# **PLANNING COMMISSION**

**MARCH 8, 2021**

**TO:** Planning and Zoning Commission  
**FROM:** Brad Scheib, Consulting Planner, HKGi  
**DATE:** February 25, 2021  
**SUBJECT:** Consider Conditional Use Permit for Drive-Through Facilities  
**APPLICANT:** Kim & Steve White  
**OWNER:** Kim & Steve White (recently closed on the property)  
**LOCATION:** 408 Main Street West; PID No. 24.150.0010  
**MEETING DATE:** March 8, 2021  
**COMPREHENSIVE PLAN:** Downtown  
**ZONING:** C-1 Central Business District

RE: Kasson, MN  
Kasson Meadows 7th  
**Review of Preliminary Plat, Preliminary Construction Plans and Rezoning Application**

02 ARCHITECTURAL SITE PLAN  
SCALE: 1/8" = 1'-0"

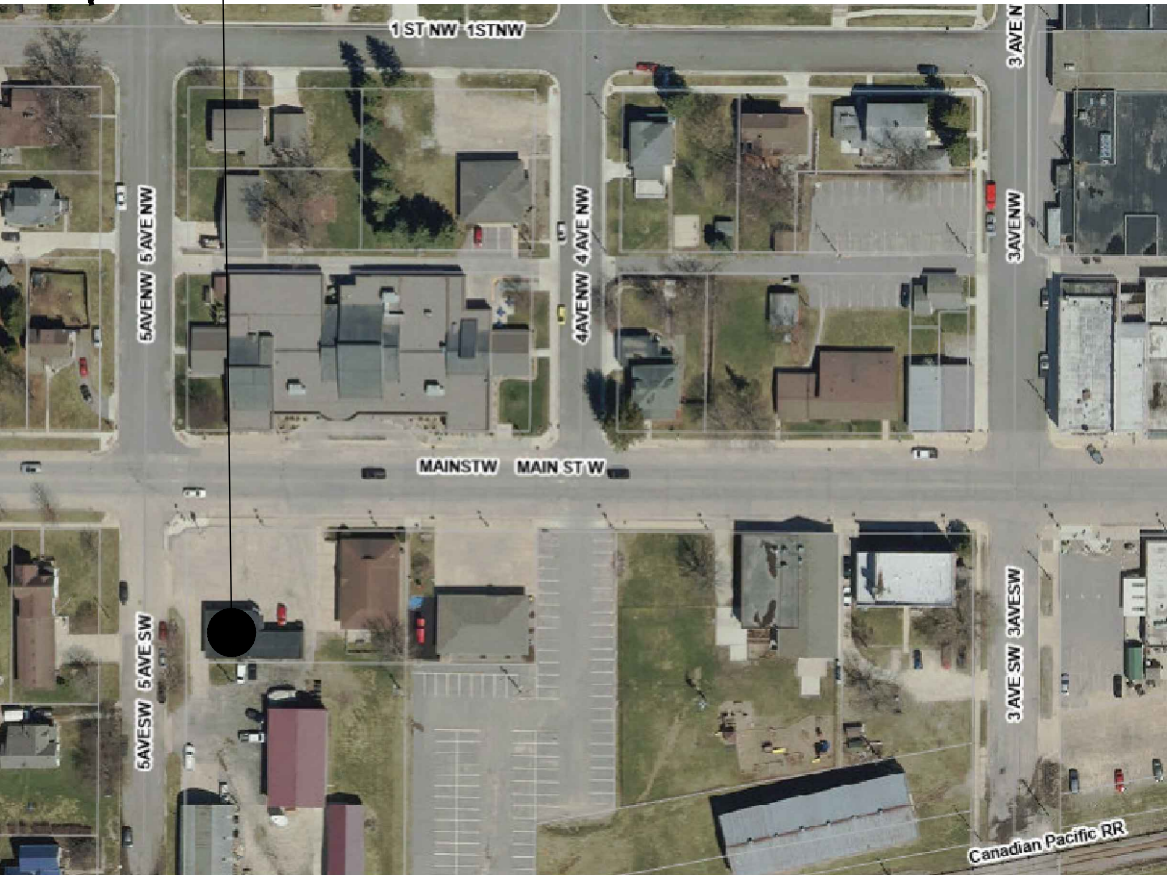
- Visual Obstructions to Vehicular Traffic – the applicant has shown the location of a “clear sight triangle” on the site plan. City fire and police staff need to review the layout to confirm the safety of the intersection with the proposed planters and seating located in the site triangle.

- (2) Queuing areas for the drive-through shall not block or intersect the sidewalk or road right-of-way of Main Street.
- (3) The existing western vehicle access to the site off of 5<sup>th</sup> Avenue Southwest shall be blocked off from vehicular traffic by means of proposed moveable planters or similar means as long as drive-through facilities are in use on site.

- (4) Delineation of the drive-through lane, by painted lines or other similar means, from the proposed patio seating area shall be added to the Architectural Site Plan prior to recording of the CUP.

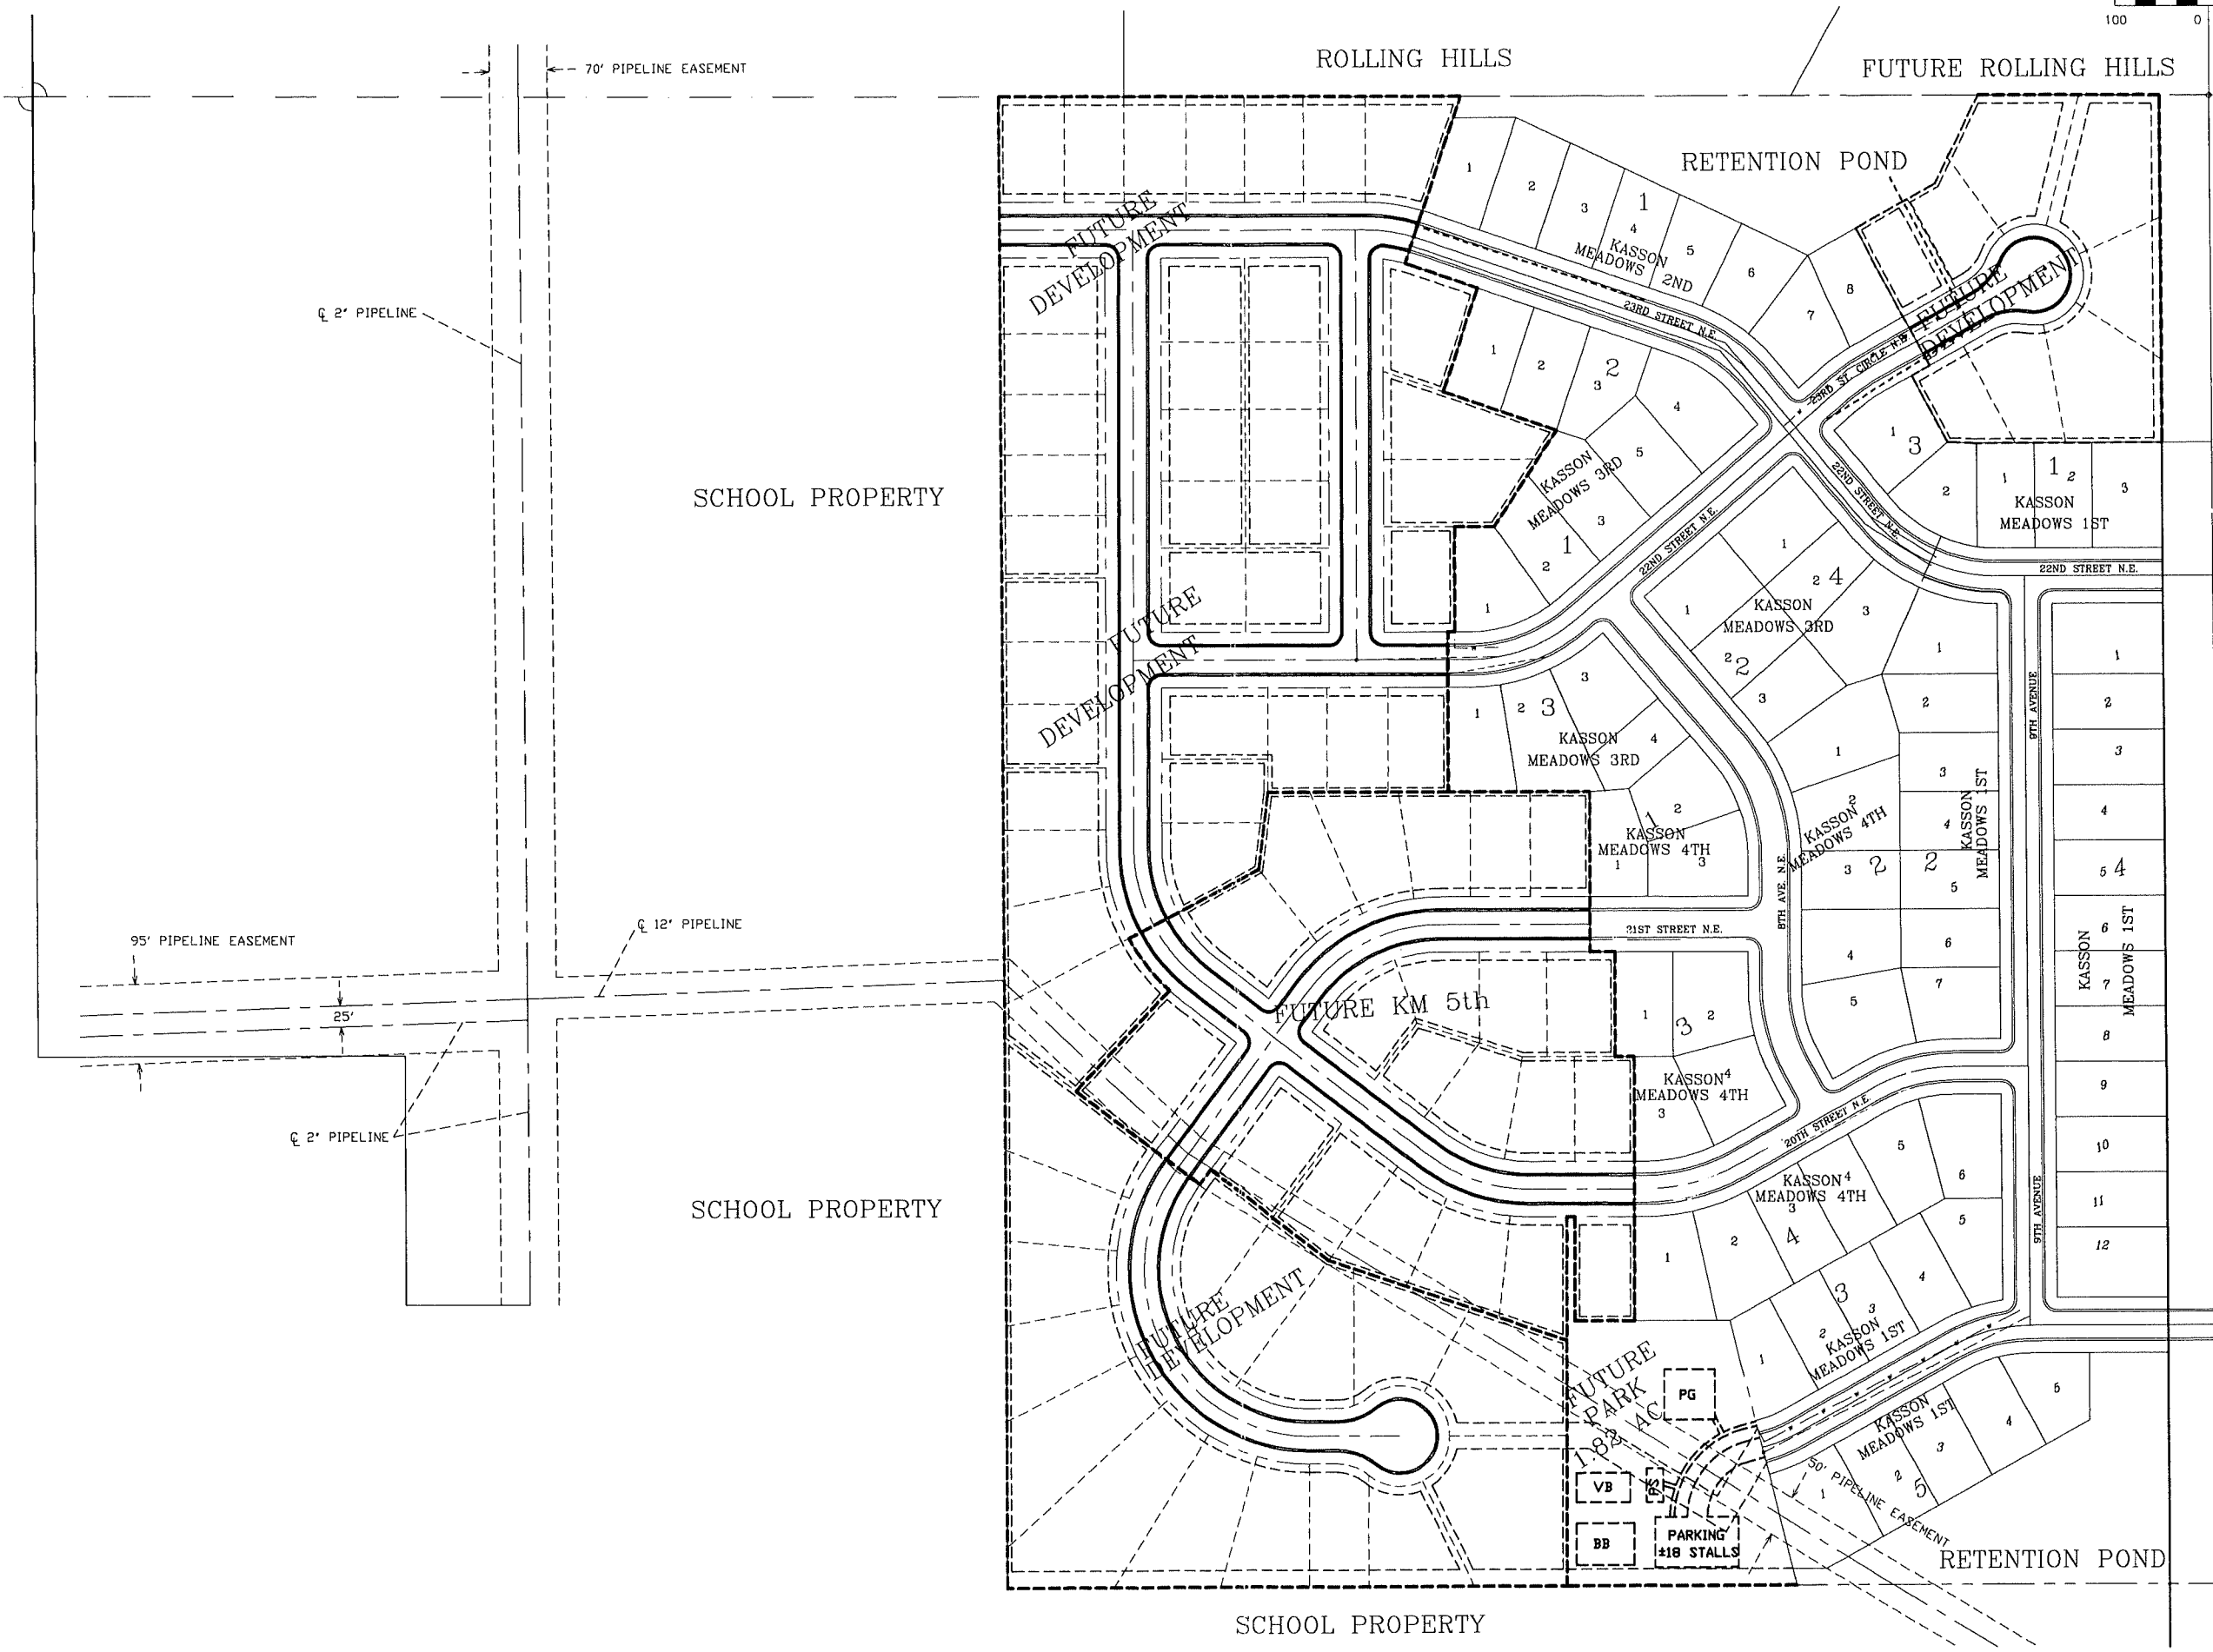
THERE ARE DISCREPANCIES BETWEEN THE LOT AREAS NOTED ON PLAN AND THE TABLE. PLEASE REVIEW AND REVISE ACCORDINGLY INCLUDING THE % OF HARD COVER. IT APPEARS THAT LOT 2, BLK 4 MAY EXCEED THE ALLOWABLE 40% MAXIMUM IMPERVIOUS SURFACE

VERIFY THAT FUTURE LOTS CAN BE SERVED BY SANITARY SEWER FROM FUTURE 23RD ST NE

VERIFY THAT 7TH AVENUE NE HAS POSITIVE DRAINAGE TO FUTURE 23RD ST NE

ADD AND LABEL EXISTING U.E

- LABEL EXISTING CONTOURS  
- SEE UTILITY MARKUPS ON THE MARKED UP CONSTRUCTION PLAN SET

PROVIDE ADA PED RAMP

Sheet 2 of 4

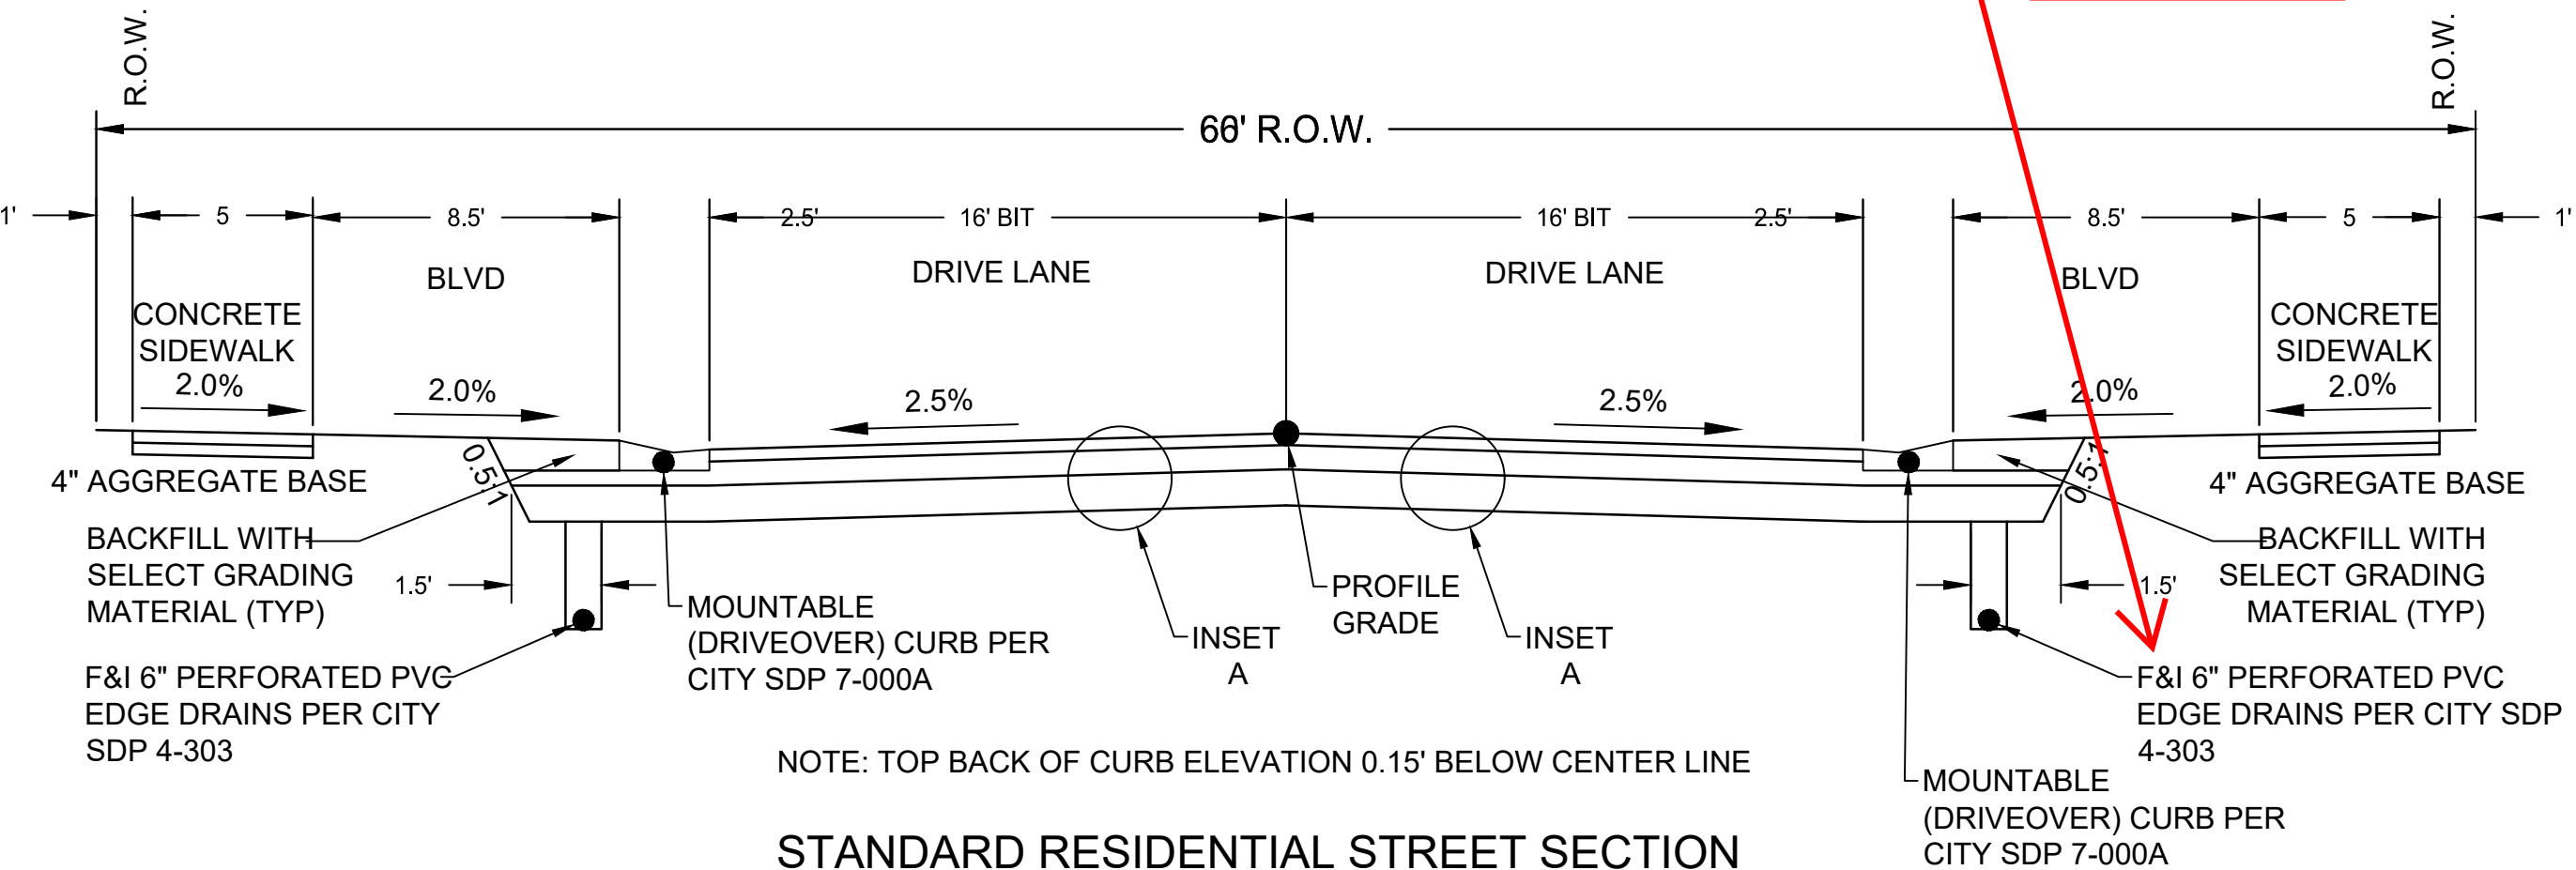
SEE MARKED UP UTILITIES ON SHEETS 3 AND 4 OF THE PLAN SET.

PROVIDE POSITIVE DRAINAGE

PROVIDE 12" OF GRANULAR BASE

SDP #'S DO NOT MATCH CITY OF KASSON STANDARD DETAILS PLEASE REVIEW AND REVISE ACCORDINGLY

LABEL EXISTING GAS EASEMENT
